MEMORANDUM

To: Montgomery Township Zoning Board of Adjustment

Re: **The Bedens Brook Club**
Use Variance and Minor Site Plan
240 Rolling Hill Road
Block 31001, Lots 38 & 39
R-5 Single Family Residential Zone

Date: March 11, 2024

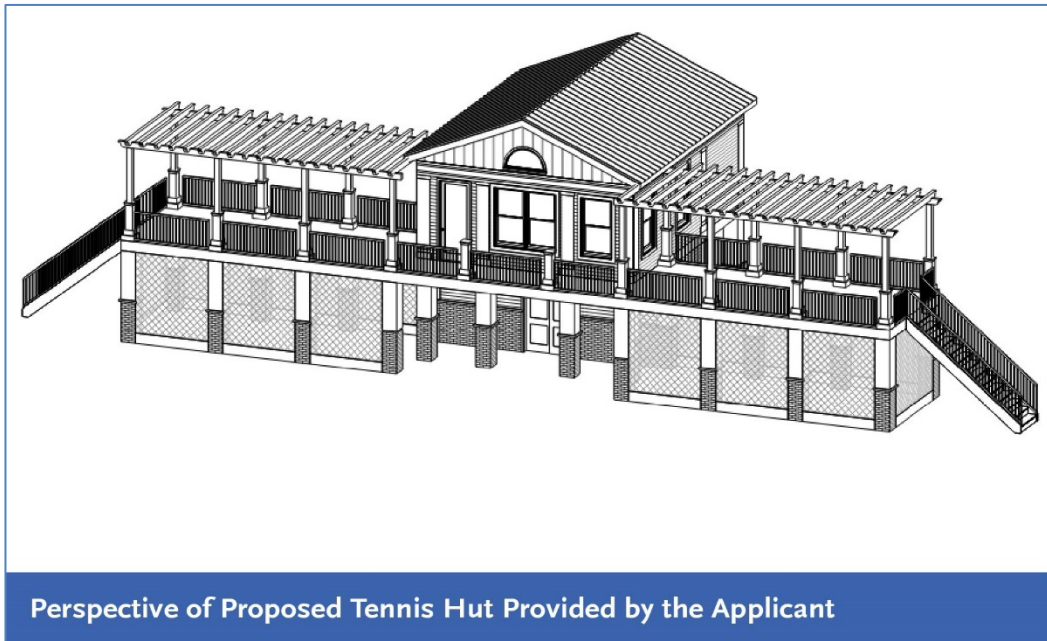
The exterior of the building is composed of a brick veneer base on the bottom of the structural components. The façade is sheathed with vinyl siding, and the roof is composed of metal. There is a lattice between the support columns that is not identified on the plan. The deck contains metal railings and is capped by pergolas on either side of the roofed portion of the upper level.

- 3.2 **Lighting:** The plans do not indicate any exterior lighting proposed on the building. The applicant should testify as to whether any lighting is envisioned or proposed for the tennis hut. **If any lighting is proposed, it should comply with §16-5.4.b.**

- 3.3 **Accessibility:** The tennis hut does not appear to be barrier-free or accessible, with the exception of the ground floor rest room which is an ADA bathroom. **It is recommended that the building be configured in a manner that is accessible to all users.**

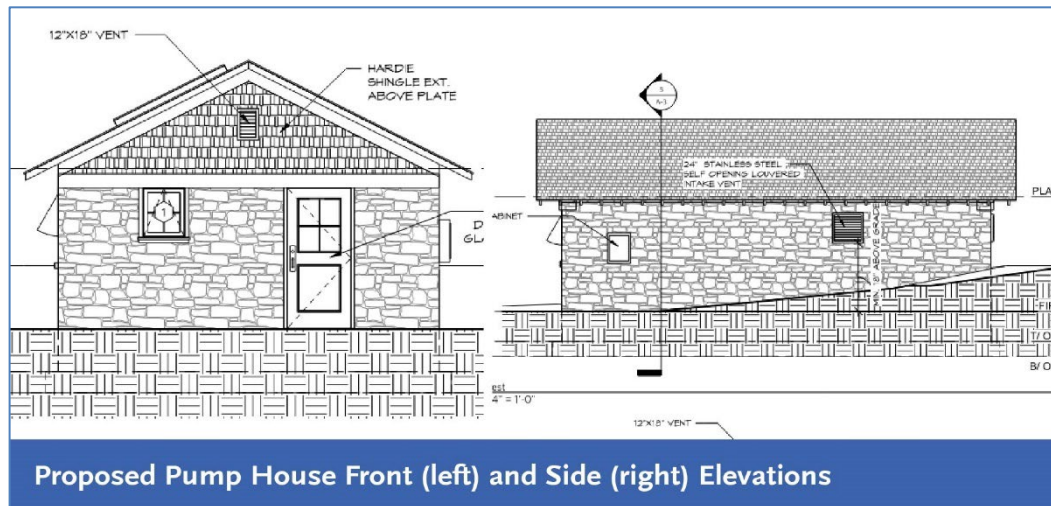
- 4.1 **Proposed Pump Station:** The proposed pump station has a footprint of 504 sf. As indicated previously, the building is just under 13 feet in height. It is composed of a stone veneer siding and a cedar shake pitched roof. The building will sit on top of a concrete well. The well connects to a pipe which runs for approximately 1,000 ft. and will be used to irrigate portions of the golf course.

- 4.2 **Lighting:** The plans do not indicate any exterior lighting proposed on the building. The applicant should testify as to whether any lighting is envisioned or proposed for the pump station. **If any lighting is proposed, it should comply with §16-5.4.b.**
